TO: Mercedes-Benz Dealer Principals, General Managers, Sales Managers, Service Managers, Parts Managers	FROM: Gregory Gunther, Department Manager, Vehicle Compliance and Analysis, Engineering Services
RE: <b>Recall Campaign Launch Notification</b> <b>Check the Transmission Wiring Harness</b> <b>MY20 GLC-Class (253 platform)</b>	DATE: August 12, 2022

## Check the Transmission Wiring Harness

Campaign No. 2022080001, August 2022

## Check transmission wiring harness, rework or replace if necessary

Figure 2, not OK condition

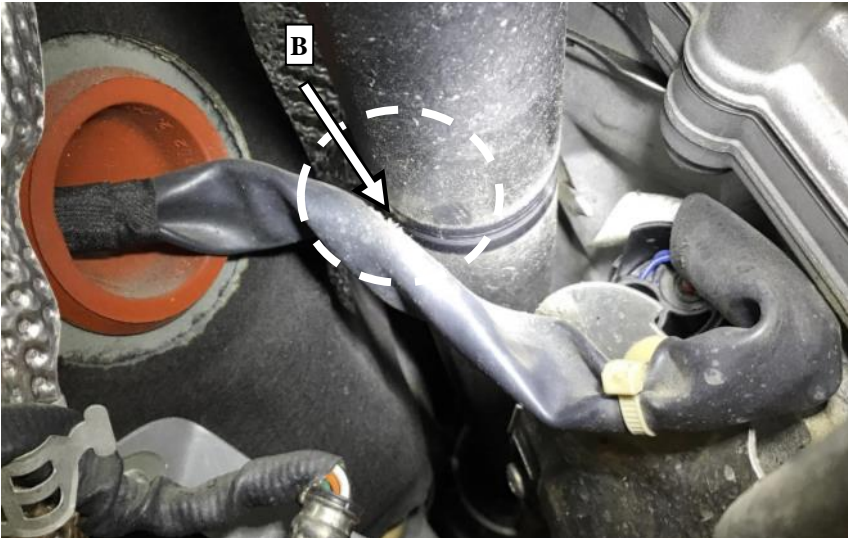
2. Check clearance (B, Figure 2) between transmission wiring harness, transmission tunnel and transmission.

**i** The transmission wiring harness **must not** lie on the drive shaft/transfer case for the front axle differential.

- a. Transmission wiring harness is in contact but **not damaged**: Perform **work procedure A**.
- b. Transmission wiring harness is in contact and **is damaged**: Perform **work procedure B**.
- c. Transmission wiring harness is **correctly routed**: **End measure**.

Figure 3, shown on model 253

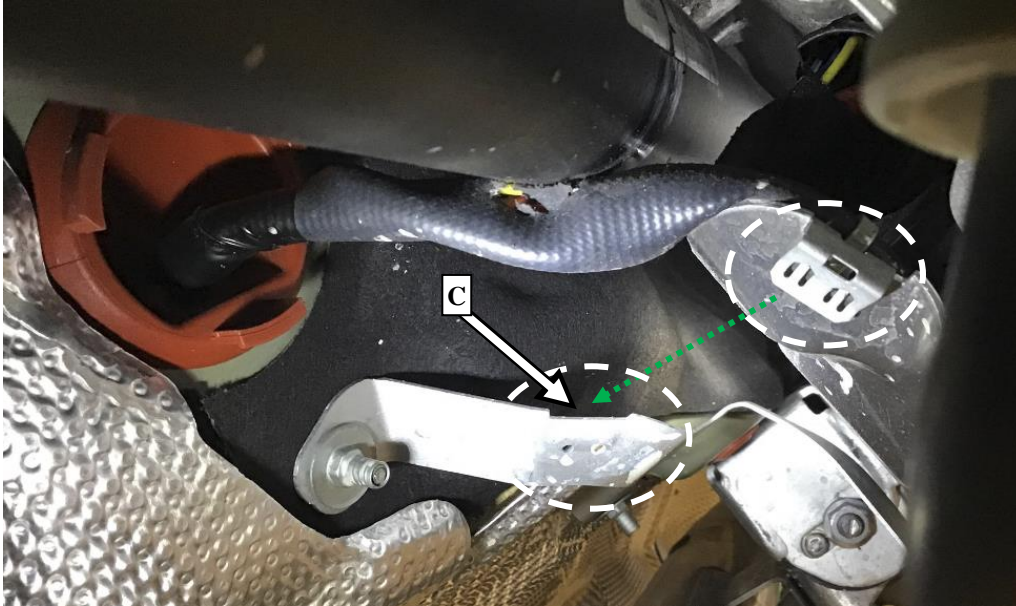
1. **For model 253** - Clip the wiring harness in at the **correct** bracket (C, Figure 3).

-  Unclip wire and retaining clamp, re-use retaining clamp on bracket (C, Figure 3).
-  It is not necessary to turn the red grommet for model 253.
